**SUBJECT:** Calvert Cliffs Nuclear Power Plant  
Unit Nos. 1 & 2; Docket Nos. 50-317 & 50-318  
Independent Spent Fuel Storage Installation Docket No. 72-8  
Changes to the Emergency Response Plan and Implementing Procedures

Enclosure: ERPIP-504, Revision 2, Change 5

**ERPIP-504**

**ENVIRONMENTAL ASSESSMENT DIRECTOR (EOF)**

ATTACHMENT 1, ENVIRONMENTAL RADIATION MONITORING SAMPLE POINTS IN THE VICINITY OF CCNPP

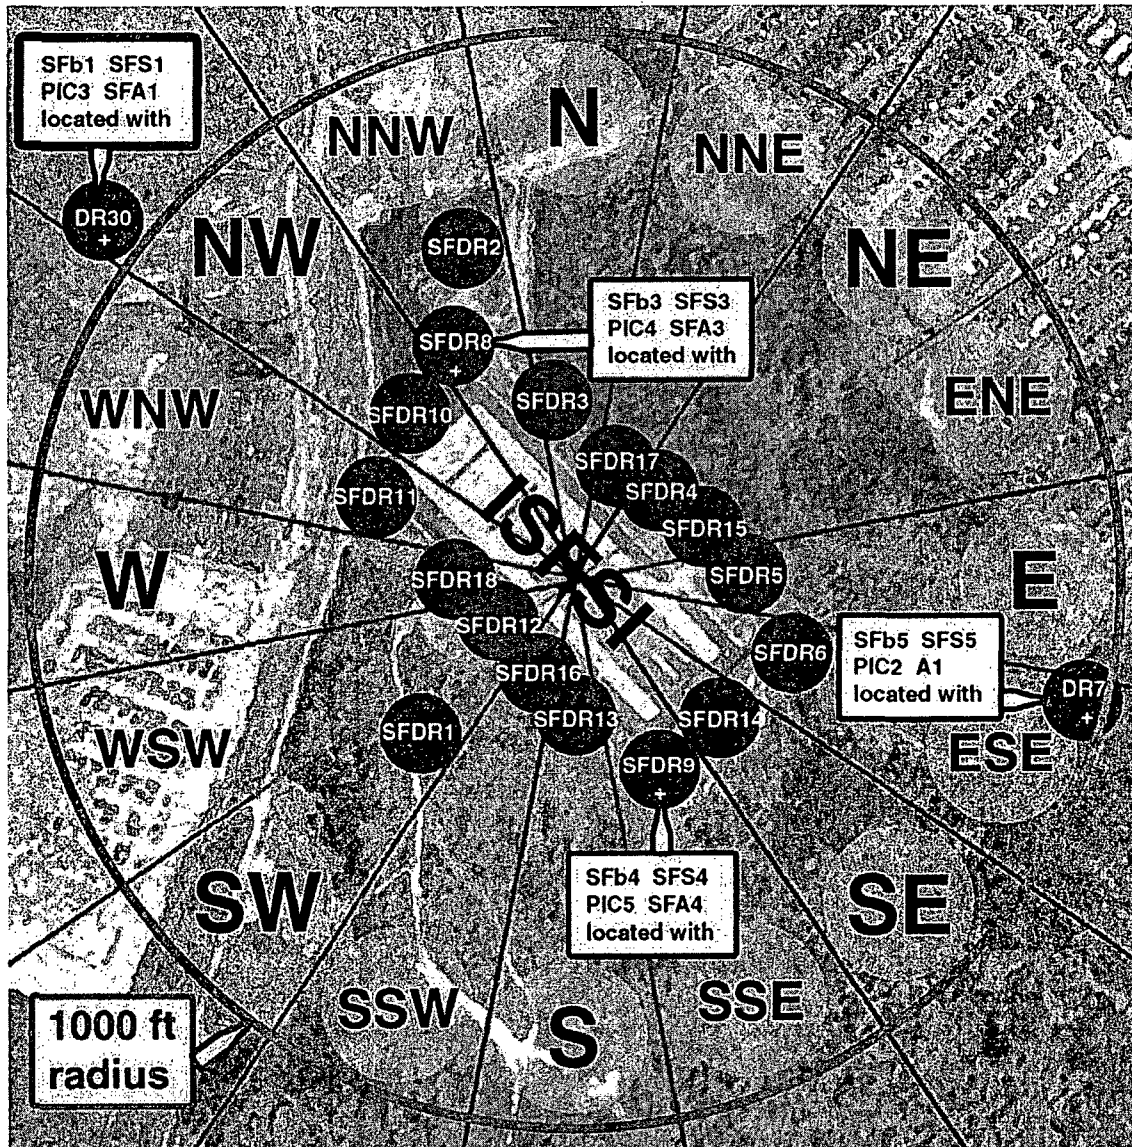
Rev.	Chg.	Summary of Revision and Changes
02	0204	Editorial correction to change the step 6.2.A Caution Note to a Warning. The Note is to protect personnel which necessitates a Warning.
002	00205	Editorial correction to update maps with more legible copies. There is no change in point locations. Incorporated additional maps to enhance point locations.  Also, updated Developmental References to align with Fleet Procedures.
